Your ref: Tilbuster 2 Solar Farm (SSD-69799460)
Our ref: 12636761

16 June 2026

Tilbuster 2 Solar Farm Response to Submissions Report – Request for Additional Information

Figure 1-4: Views across landforms within PAD 1.

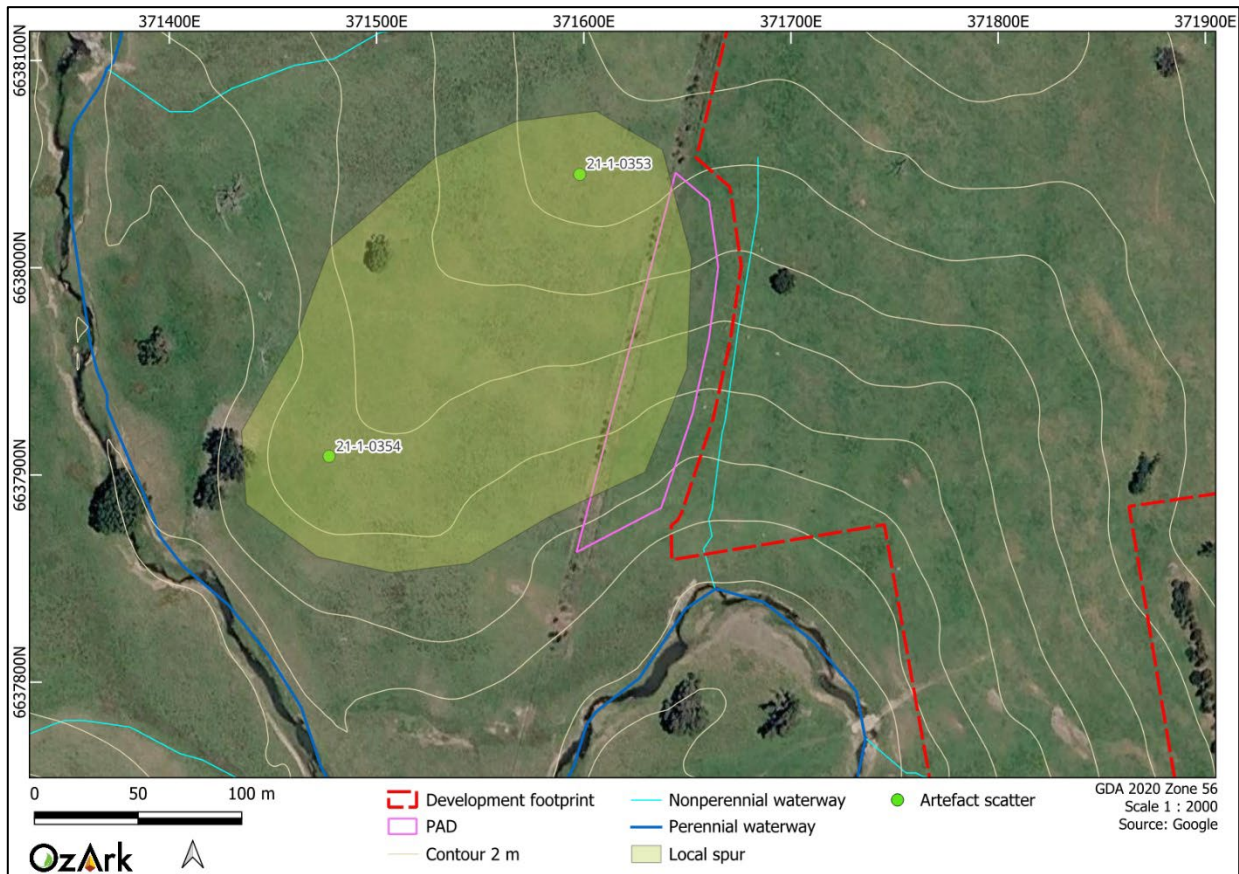
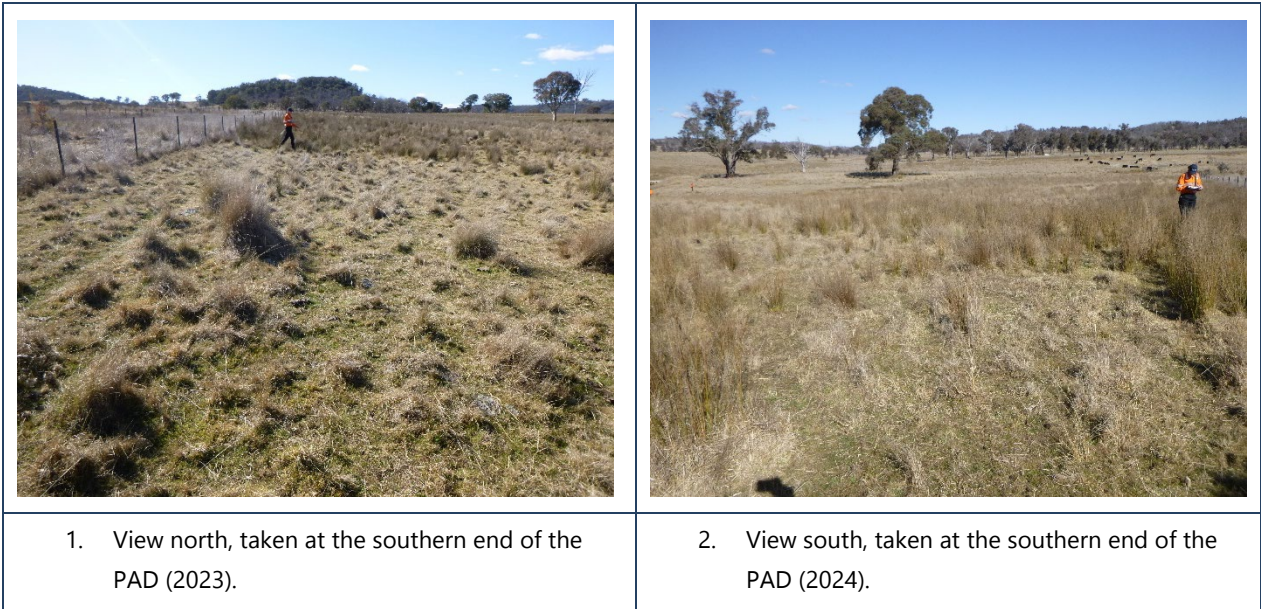
The ACHAR indicates that site and PAD boundaries were primarily based on landform classification. However, inconsistencies exist between site descriptions and mapped landforms. For example, 'Tilbuster Stage 2 PAD 4' (AHIMS 21-1-0587) is described as being on an elevated rise/localised crest (Table 6.5) yes Figure 6.3 places it within an area mapped as a gentle slope.

The landform at Tilbuster Stage 2 PAD 1 (hereafter 'PAD 1') is situated within a broader landscape of gentle slopes, within which subtle microtopographic changes manifest as a local spur comprising flat to very gentle slopes. The local spur is surrounded by more prominent, albeit still gentle, slopes which descend into ephemeral drainage gullies to the west and east. **Figure 1-1** illustrates these topographic and hydrological features, utilising 2 metre (m) interval contours. Within PAD 1, the northern portion comprises a gentle slope which recedes southerly into a slight flat bench overlooking Duval Creek (**Figure 1-4**).

Figure 2-3: PV panel construction area in relation to PAD 4.

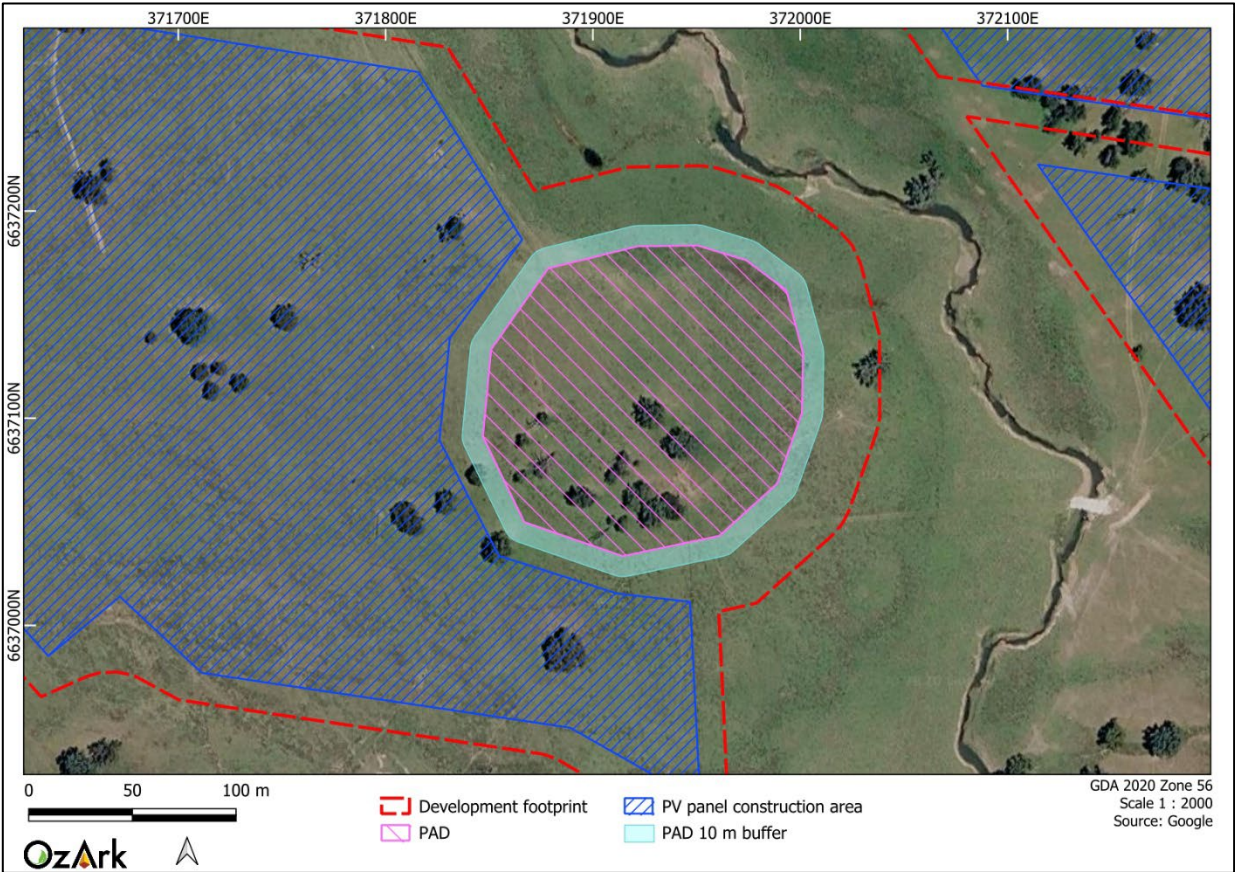
The ACHAR concludes that test excavations are unnecessary because data from previous excavations completed by NGH within 'Tilbuster Solar AS24' (AHIMS 21-2-0354) and 'Tilbuster Solar AS25' (AHIMS 21-1-0353) can be extrapolated to predict similar subsurface conditions for the PADS recorded as part of the current assessment. While the nature of subsurface archaeological deposits may be inferred, these results do not establish PAD boundaries. The extent of archaeological deposits cannot be confirmed without testing.

The redesign of the proposal layout places the PV panel areas a further 20 m west of PAD 4, well away from the higher potential portion of the PAD to the east, which is associated with closer proximity to Duval Creek (**Figure 2-3**).

This clarification of the landform adds assurance that ground disturbing works associated with the construction of the PV panels will not impact the landform that is assessed as having high archaeological potential. This additional information and analysis provided regarding PAD 4 reiterates the ACHAR’s conclusion that test excavation is not warranted as ground disturbing works will completely avoid the area of identified archaeological sensitivity.
